UNITED STATES PATENT AND TRADEMARK OFFICE

APPLICATION NO.	FILING DATE	FIRST NAMED INVENTOR	ATTORNEY DOCKET NO.	CONFIRMATION NO.
10/672,022	09/26/2003	Neal E. Ulen	P16919	7687
28062	7590	10/25/2005	EXAMINER	
BUCKLEY, MASCHOFF, TALWALKAR LLC			PAPE, ZACHARY	
5 ELM STREET			ART UNIT	
NEW CANAAN, CT 06840			PAPER NUMBER	
			2835

Office Action Summary	Application No. 10/672,022	Applicant(s) ULEN ET AL.	
	Examiner Zachary M. Pape	Art Unit 2835

DETAILED ACTION

Fig 1

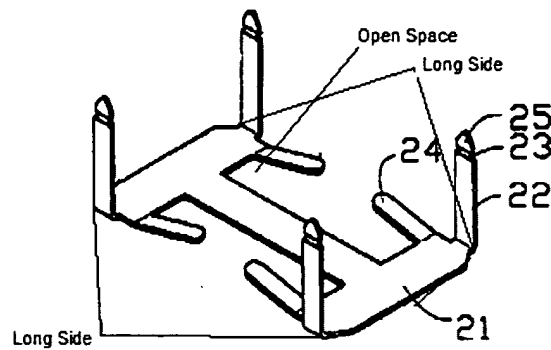
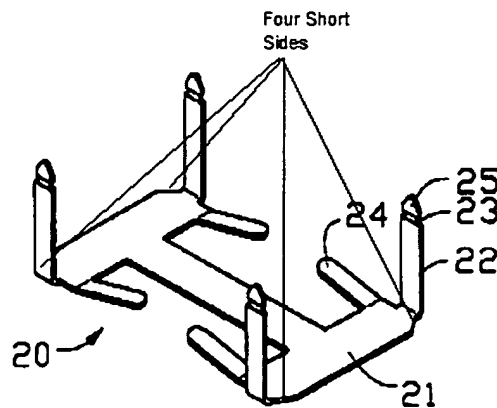
With respect to claim 11, Lee teaches a spring (Fig 3, 20) comprising: a perimeter section including a plurality of sides around an open space a first spring finger (24) extending inwardly and upwardly in an inclined fashion from a first one of the sides; a second spring finger (Also 24) extending inwardly and upwardly in an inclined fashion from a second one of the sides that is opposite to the first one of the sides; four board attach fingers (25) each extending substantially vertically upwardly from the perimeter section, a first one of the board attach fingers located at a first end of the first one of the sides a second one of the board attach fingers located at a second end of the first one of the sides, a third one of the board attach fingers located at a first end of the second one of the sides, and a fourth one of the board attach fingers located at a second end of the second one of the sides, and four bosses (22) formed in the perimeter section each of the bosses located so as to have a respective one of the board attach fingers (25) extending upwardly therefrom: wherein the perimeter section is substantially octagonal and includes a pair of long sides that are positioned opposite to each other and that are longer than the sides from which the first and second spring fingers extend, the perimeter section further including four short sides that are shorter than the sides from which the first and second spring fingers extend, each of the short sides joining an end of one of the long sides to an end of one of the sides from which the first and second spring fingers extend; said long sides (See present office action Figs 1 and 2 below).

Lee fails to teach that the short sides and said sides from which the first and second spring fingers extend together forming a closed octagonal loop, however it would have been obvious to one of ordinary skill in the art at the time the invention was made to connect the two spring fingers (24) on each side respectively to close the gap between the two springs forming a closed loop and thus increasing the rigidity of the spring fingers.

With respect to applicants' remarks that the, "closed loop configuration is not suggested by either element 10 of the Chen reference or element 20 of the Lee reference nor from their combination", the examiner respectfully agrees, however, as set forth in the rejection to claim 11 above, modifying the spring to have a closed loop is an obvious modification to the existing design (Of Lee) since connecting the spring fingers (24) would add rigidity to the spring.
